EMERALD HEIGHTS
COURTYARD INDEPENDENT LIVING

DESIGN REVIEW 100%

DESIGN REVISIONS - INITIAL DRB SUBMISSION

Design Revisions: Responding to Input

DESIGN REVISIONS FOR CONTINUITY

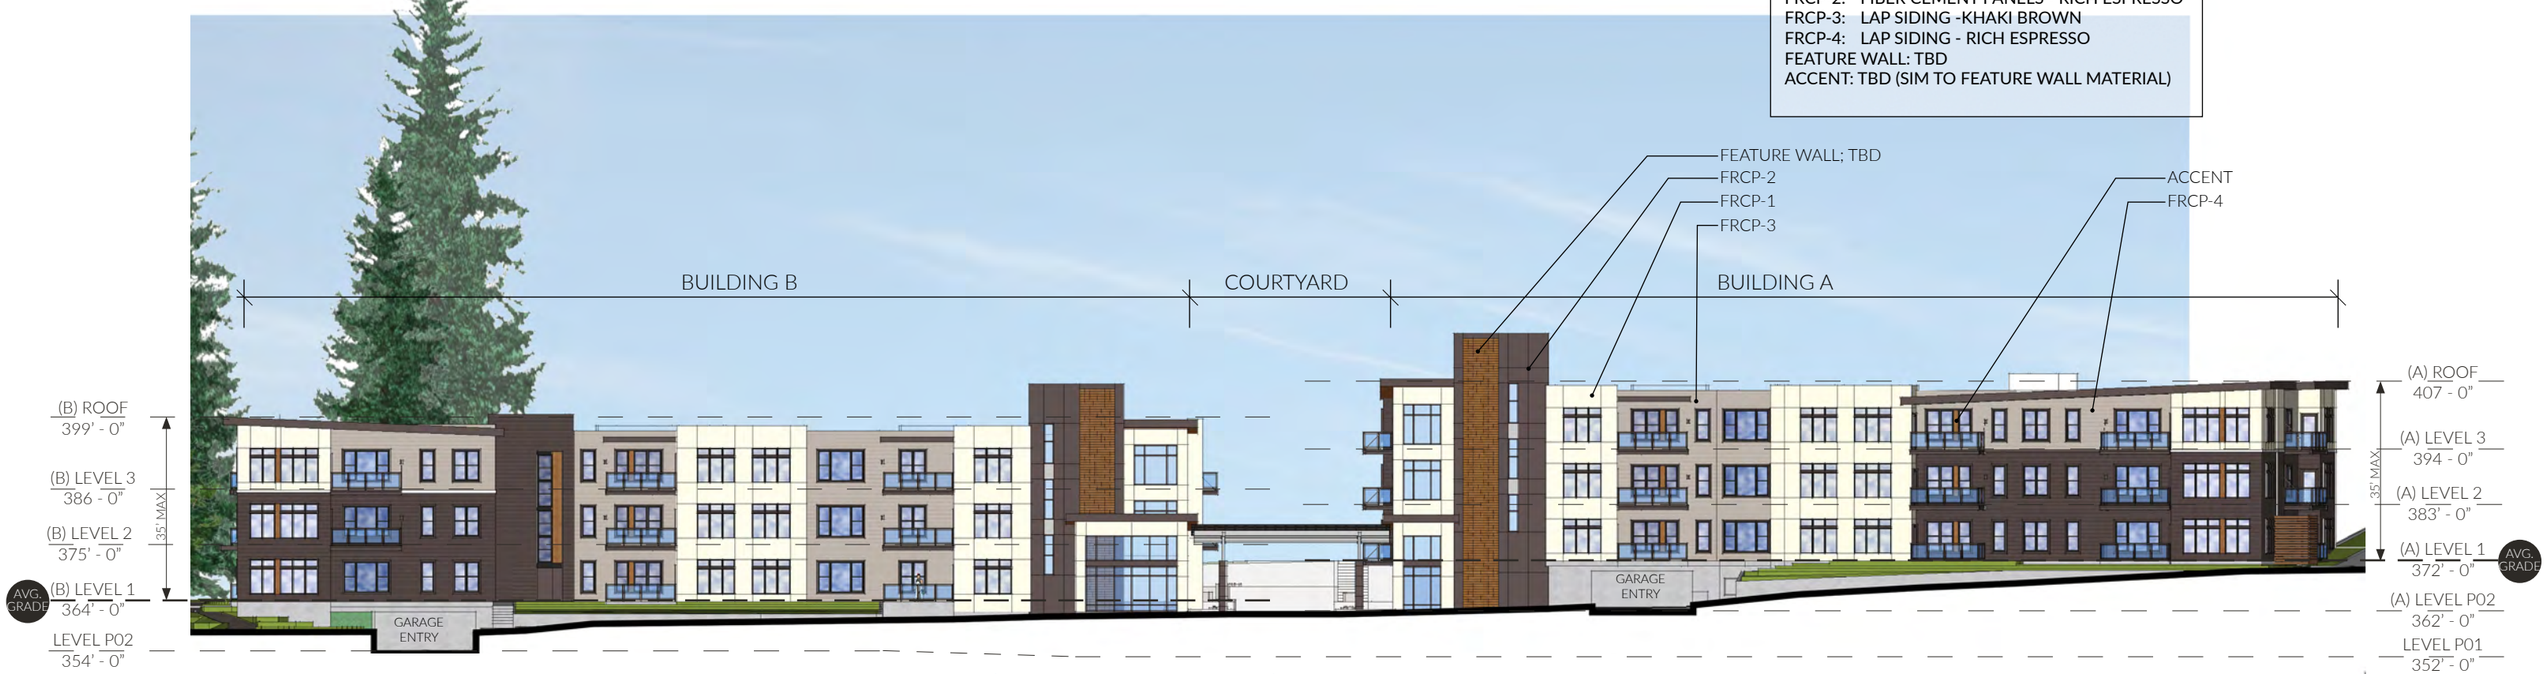
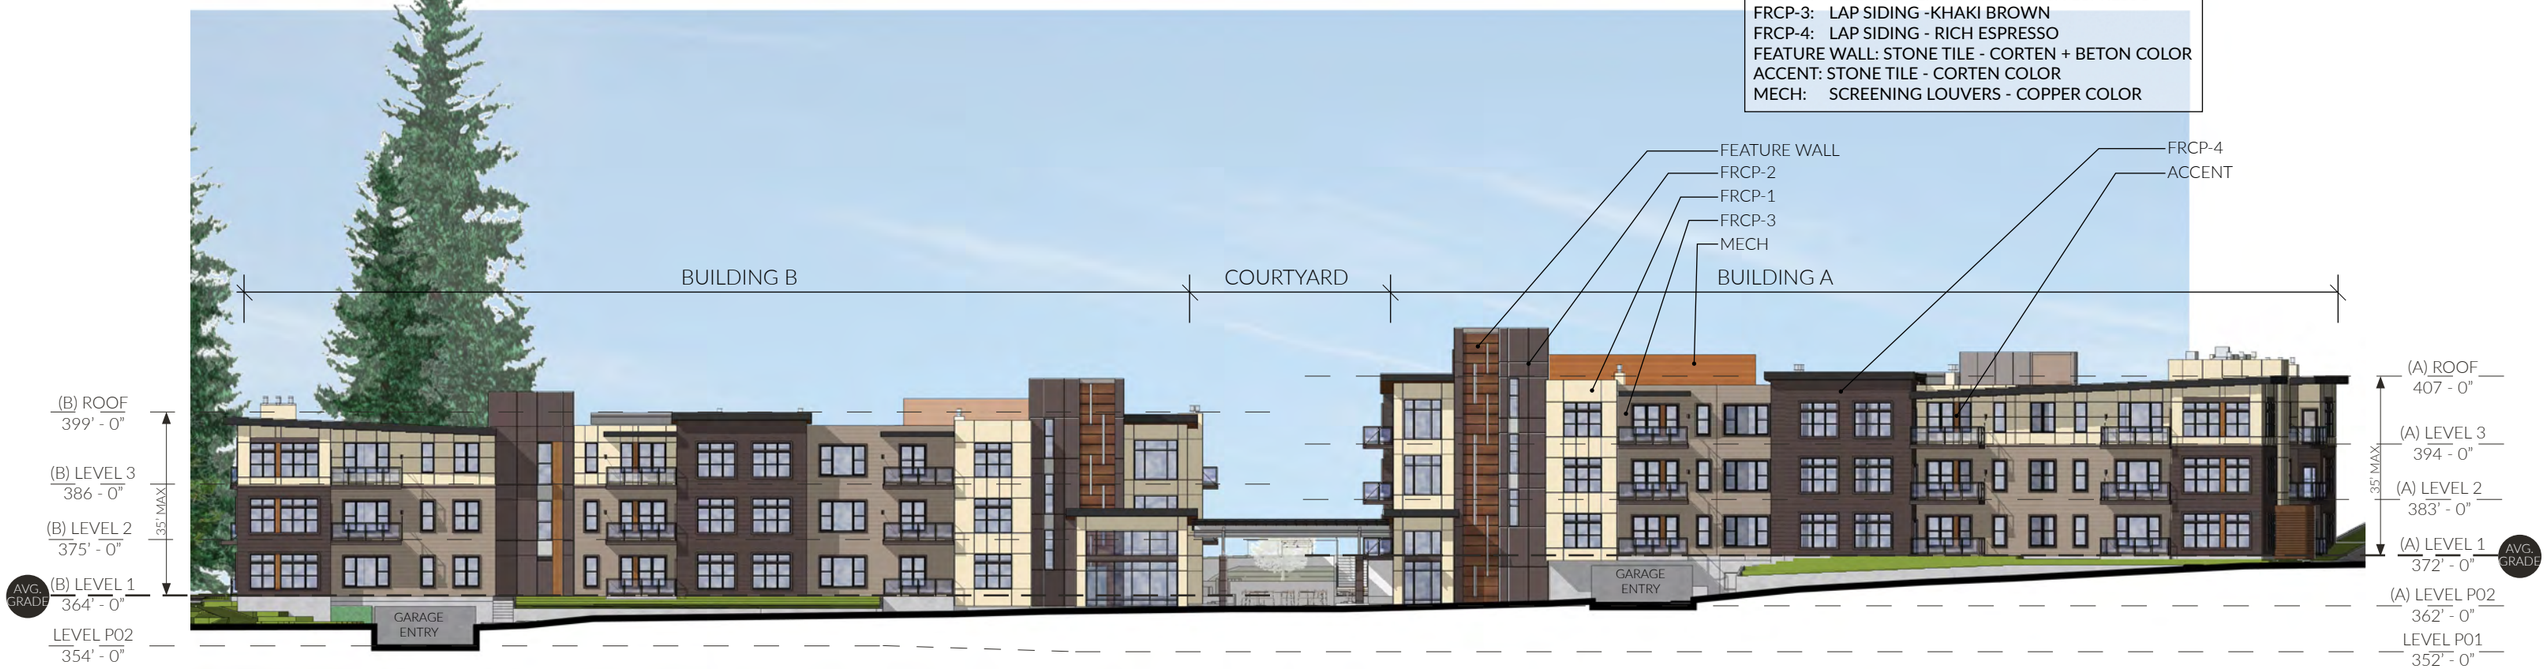
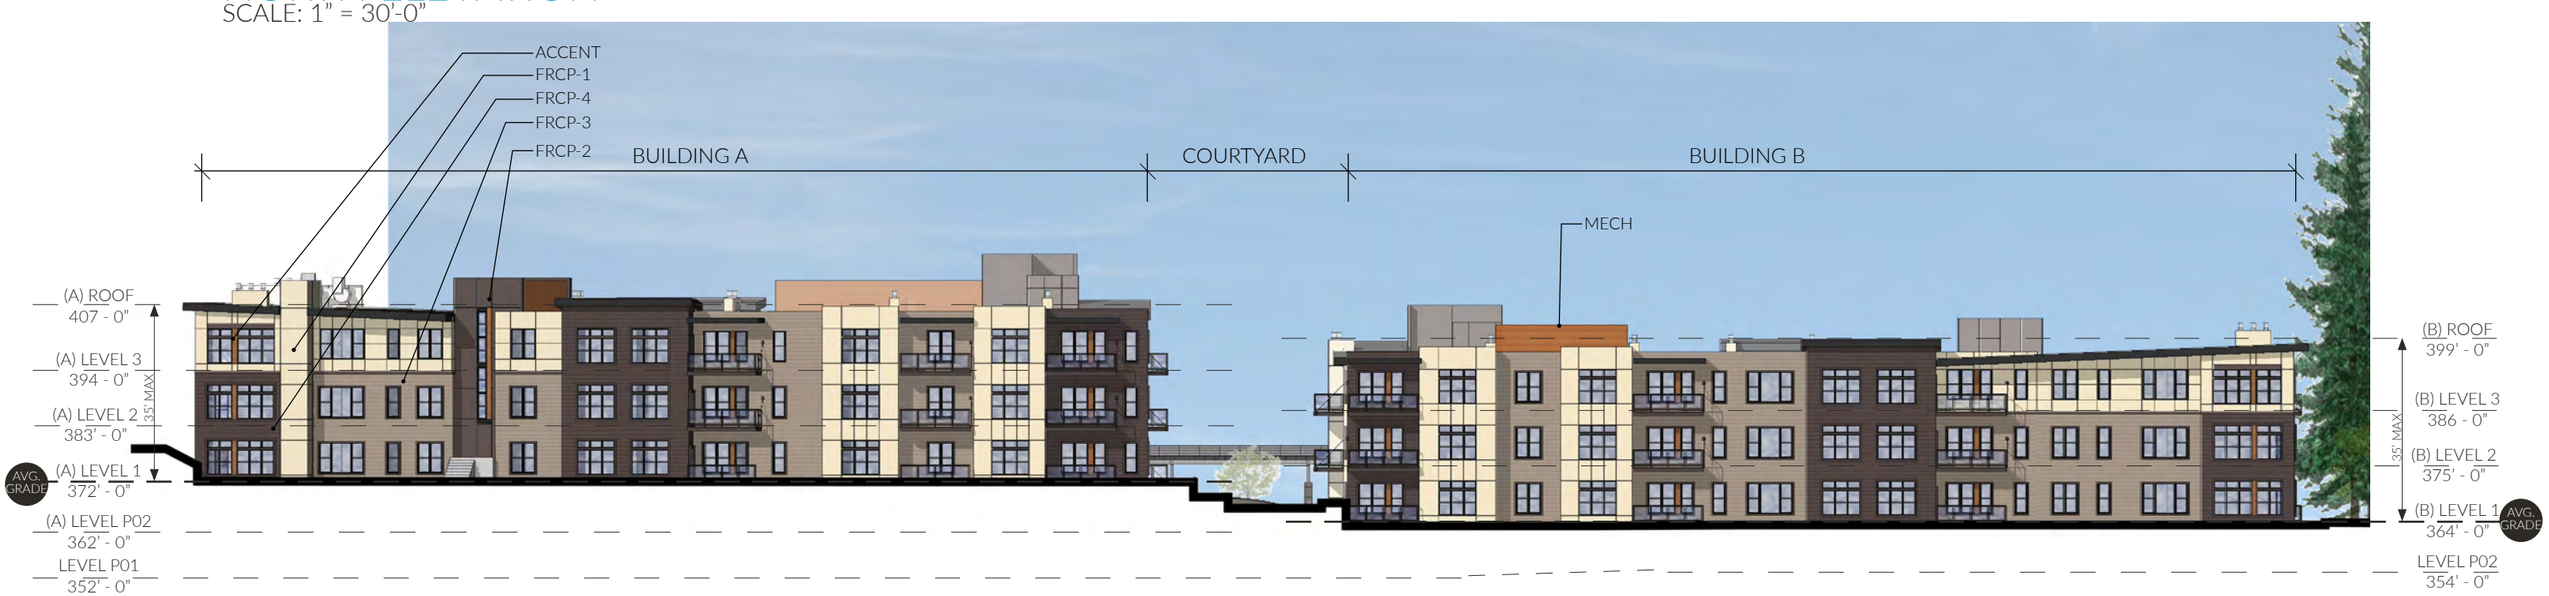
LARGE PROJECTED BAYS REVISED FROM PANEL TO RICH ESPRESSO LAP SIDING. VERTICAL ELEMENTS IN THE BUILDING MASSING ARE ALL SHOWN WITH THIS COLOR AND HELP TO REDUCE BUILDING MASS

REVISED COLOR SCHEME ALLOWS FOR ENHANCED CONTRAST AT BALCONIES

MATERIALS REVISED TO MATCH TRAILSIDE PALLET; NAVAJO BEIGE PANEL OVER KHAKI BROWN LAP SIDING IN LIEU OF DESIGN SHOWN ABOVE. CREATES STRONG HORIZONTAL LANGUAGE AT BUILDING ENDS

BAY WINDOWS RETAINED WHERE SCALE IS SIMILAR, PANEL ARTICULATION ADJUSTED TO CREATE STRONGER REFERENCE TO TRAILSIDE
